Access Compliance Report

Public Rights-of-Way

(Pedestrian Signals)

Intersection ID: N/A	Main Street:	Cross Street: N/A	Location: N/A
ADA ID: BC695CFEBDA0	Signal Type: One Push Button-Non APS	Overall Compliance: No	Severity Score: BTN 1: N/A BTN 2: N/A No BTN: N/A
Codes/Mitigation Info/Possible Solution		Field Measurements/Component Compliance

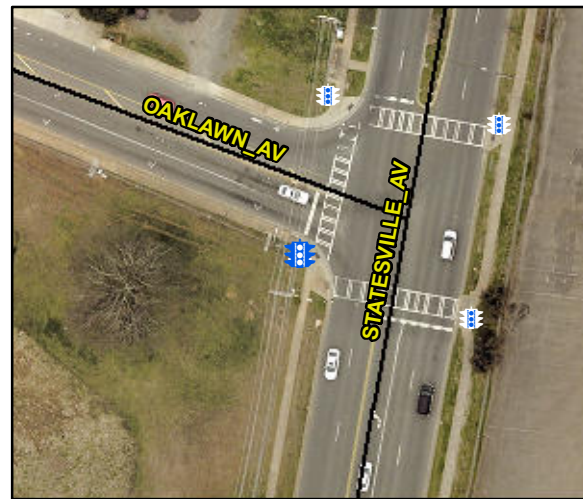
Surveyor Notes: TX HT 5/16

PROW/ADA: R410.6, TMUTCD 4e.08, R404.2, R406.2, R404.7.3

Yes	B 1 Clear Xing Direction?	ClearlyMarked	N/A	B 2 Clear Xing Direction?	N/A
	B 1 Crossing Direction	To E		B 2 Crossing Direction	N/A
Yes	B 1 DistanceTo XWalk (in)	31.0	N/A	B 2 DistanceTo XWalk (in)	N/A
No	B 1 DistanceTo Curb (in)	188.0	N/A	B 2 DistanceTo Curb (in)	N/A
Yes	B 1 Diameter (in)	2.0	N/A	B 2 Diameter (in)	N/A

Possible Solutions: Replace Signal Push Button With APS Button on New Post. Remove & Replace Sign.
